Bulletin No. 160_OS7400_T_Series

New Product Announcement

OfficeServ 7400 T-Series Data Modules V.1.32

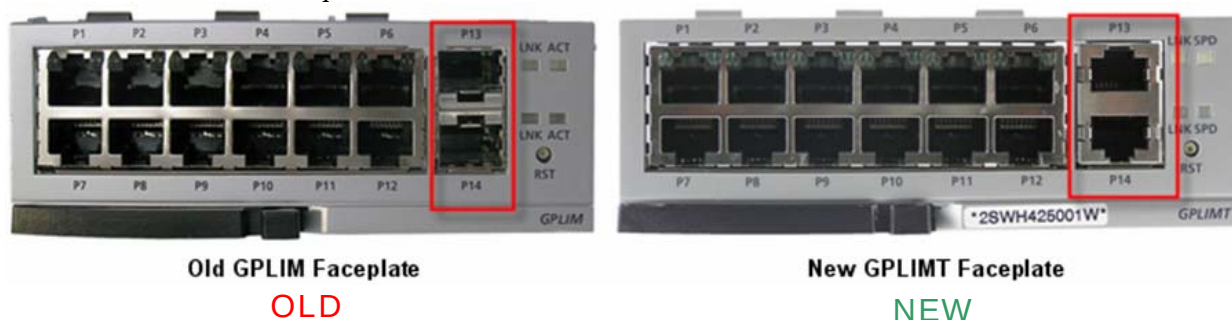
GWIMT changes: The SFP cages found on the GWIM model router has been replaced with RJ-45 connectors which support 10/100/1000 Base-TX connectivity. The SIO port has been

relocated to be grouped with the Ethernet Interfaces. These changes were implemented due to customers' continued requests for RJ-45 10/100/1000 Base-TX interfaces.

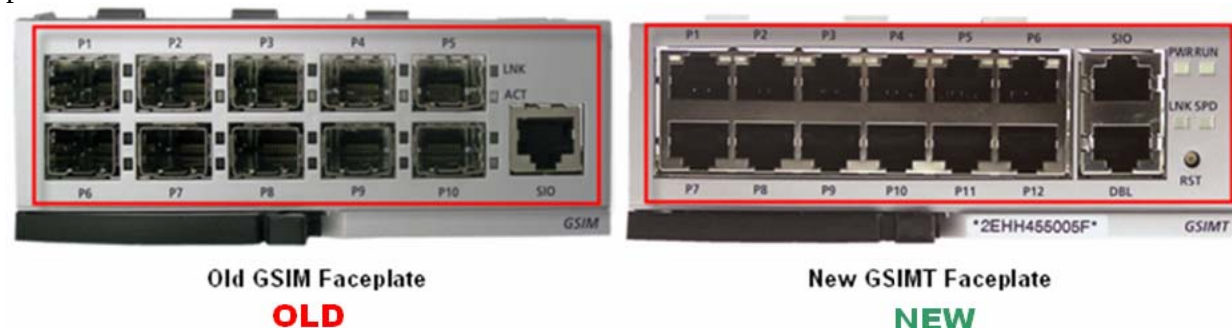
GPLIMT changes: The SFP cages found on the GPLIM model router has been replaced with RJ-45 connectors which support 10/100/1000 Base-TX connectivity. This change was implemented due to customers' continued requests for RJ-45 10/100/1000 Base-TX Ethernet ports.

GSIMT changes: The SFP cages found on the GSIM model router has been replaced with RJ-45 connectors which support 10/100/1000 Base-TX connectivity. The Ethernet port count has been increased from 10 (GSIM) to 12 (GSIMT). The SIO port has been moved up and a debugging port named DBL has been added. These changes were implemented due to customers' continued requests for RJ-45 10/100/1000 Base-TX Ethernet ports.
